Our Ref: 1238

Hinckley National Rail Freight Interchange  
C/O Lexington Communications  
3<sup>rd</sup> Floor, Queens House  
Queen Street  
Manchester  
M2 5HT

## **PUBLIC CONSULTATION REPOSENSE ON BEHALF OF STONEY STANTON PARISH COUNCIL HINCKLEY NATIONAL RAIL FREIGHT INTERCHANGE**

Figure 15 (page 133) of Leicester and Leicestershire Authorities Report Warehousing and Logistics in Leicester and Leicestershire: Managing Growth and Change

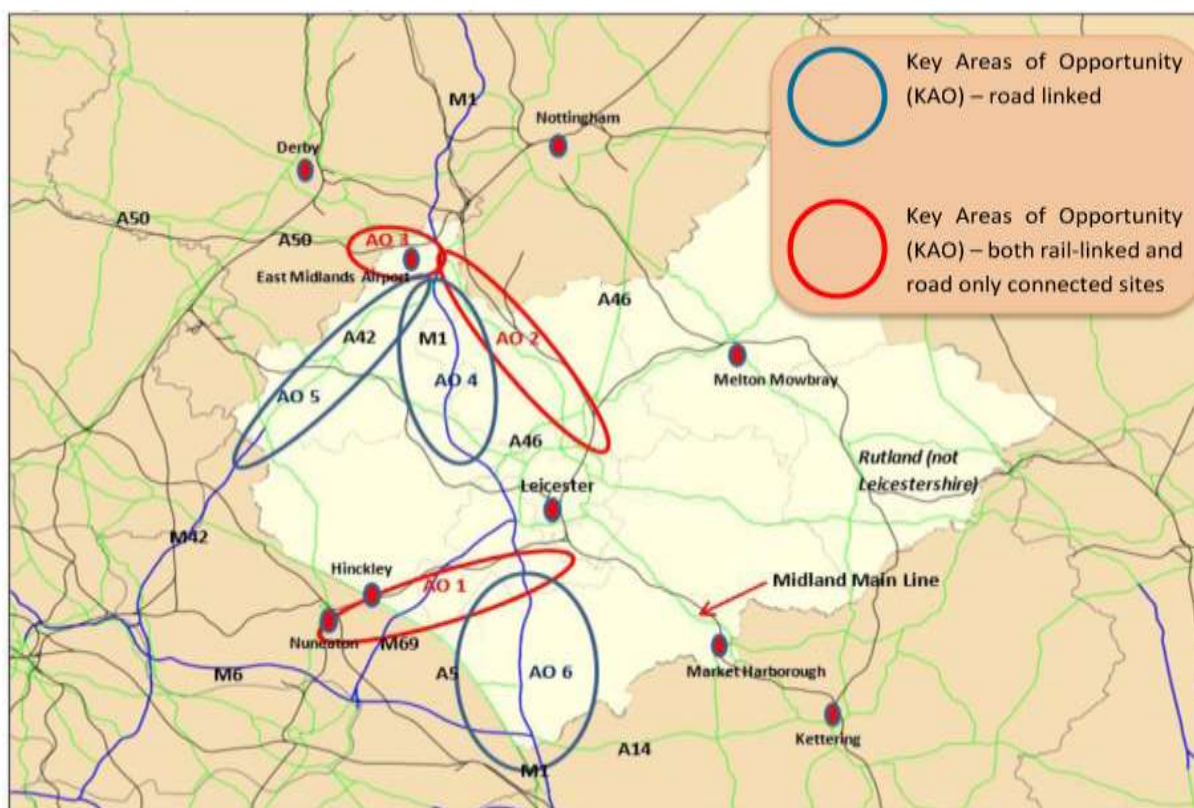
The selected site and assessment undertaken has been based upon land within Leicestershire coming forward. Whilst the areas of opportunity as noted on Figure 15 of the Leicester and Leicestershire Authorities Warehousing and Logistics Report states that these areas are only indicative and not precise, it is clearly illustrating within Area A01 the desire to provide employment between Leicester and Hinckley, juxtaposed to the Leicester-Nuneaton trainline. The supporting text of paragraph 11.8 reconfirms the visualisation of Figure 15.

However, there is no particular reason why the boundary of Leicestershire needs to be taken as a sacrosanct search area. Such a facility could just as realistically be delivered between Hinckley and Nuneaton to meet the same localised desired need, just within Warwickshire. There is a section of land to the south of the A5 (trunk road) that has a straight section of railway line where a rail-lined facility could be delivered. The A5 offers a close, direct link back to the M69, with scope then to provide access to existing trunk roads to the north, south, east and west, without the need for expensive connecting roads or direct concerns of vehicles travelling through adjacent villages. No sites beyond Leicestershire appear to have been considered though; since this site would still offer the same benefits to the local area, this appears to be a major shortfall in the robustness of the initial consideration of sites to serve the Midlands area, a point noted repeatedly within the consultation documentation.

Figure 17 (page 43) of PEIR Appendix 8.1 Interim Transport Assessment

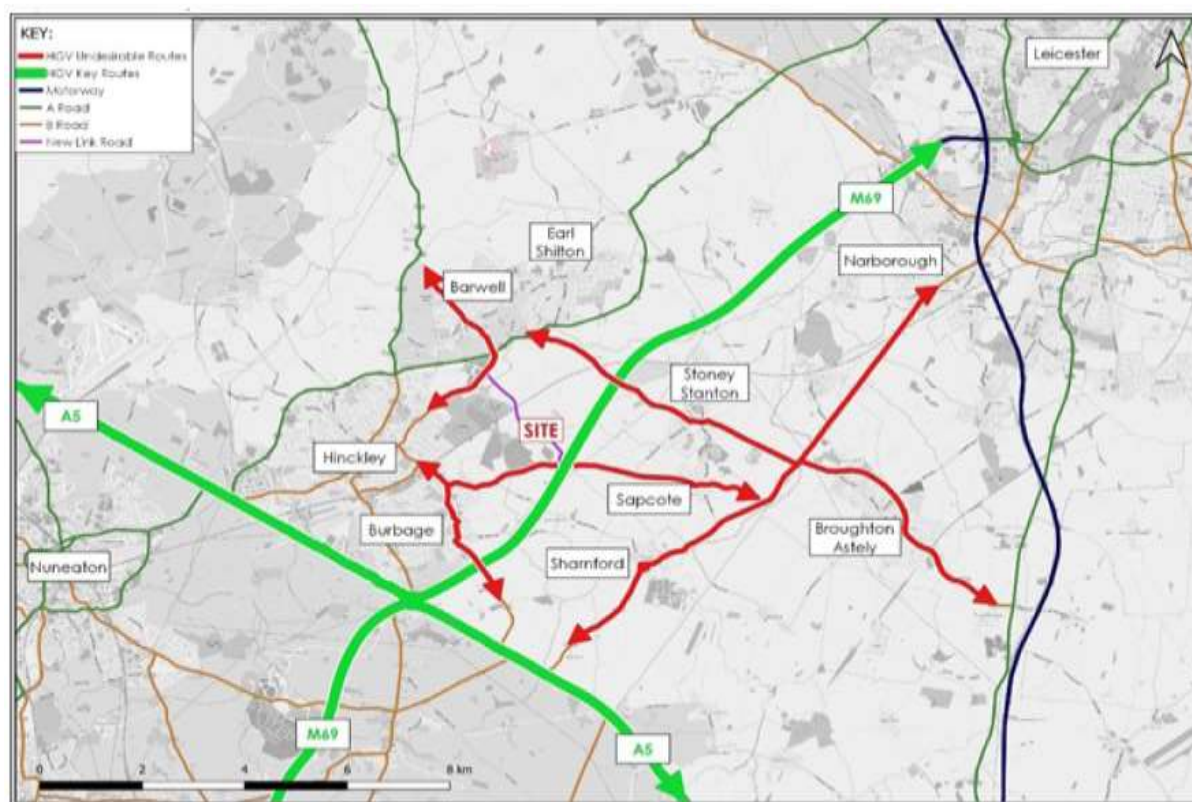
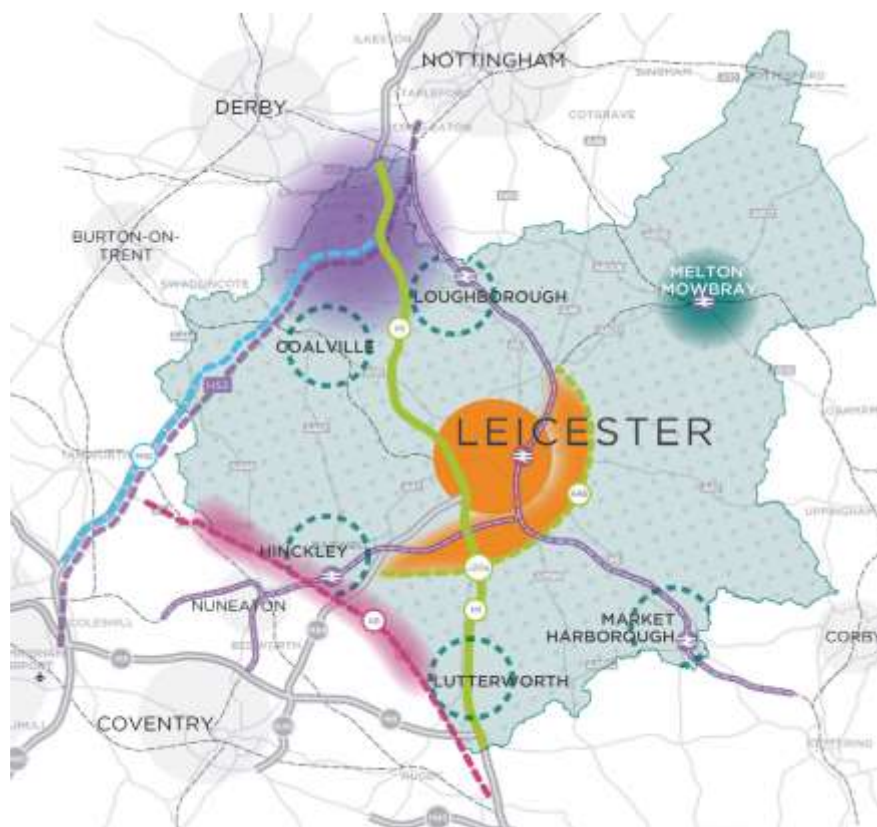
- 3.4 In terms of the highways information that has been presented, from an overview perspective the written Preliminary Environmental Information Report and supporting technical reports present a different position to that stated at the consultation events (presentation information/verbal communication by BWB Highway representatives). Supposedly, all HGV movements from the new development would be directed via the key highway roads (M69 primarily) and not via the secondary roads which run through the surrounding villages. These are highlighted on Figure 17 of the Interim Transport Report as '*HGV desirable routes*' and '*HGV undesirable routes*', with the latter noted to include routes through Stoney Stanton, Sapcote, Barwell, Burbage/Hinckley and Narborough. Ensuring no vehicles come via these routes even with a Travel Plan etc in place is very difficult for Tritax Symmetry to enforce, particularly if container collection is offered, as there is even less ability to control the routes taken by such vehicles. Tritax Symmetry have made reference to the ability to use an Automatic Number Plate Recognition System to control the routes taken, but even this would be difficult to enforce for the HGVs and impossible to control any employee movements, which are likely to be in the thousands every day, given the lack of any public transport or safe ability to travel by non-car borne modes.

- 3.5 Notwithstanding the position presented at the consultation events, it has been indicated within the PEIR Chapter 8: Transport and Traffic section at Table 8.5 (page 8-44) that there would be quite considerable increases in HGVs along many of these roads. This includes in the centre of Sapcote on the B4669 Hinckley Road between Stanton Lane and Sharnford Road (+236.4% change), with the expected level of growth with and without development cited. The development, whether bringing this traffic directly or indirectly is therefore having a very significant impact upon the surrounding highways and settlements, regardless of the intentions of the proposals. This then leads to a second very important question on whether a new bypass should be provided around Sapcote, to mitigate against this severe increase in HGV traffic, as well as increased traffic levels as a whole.
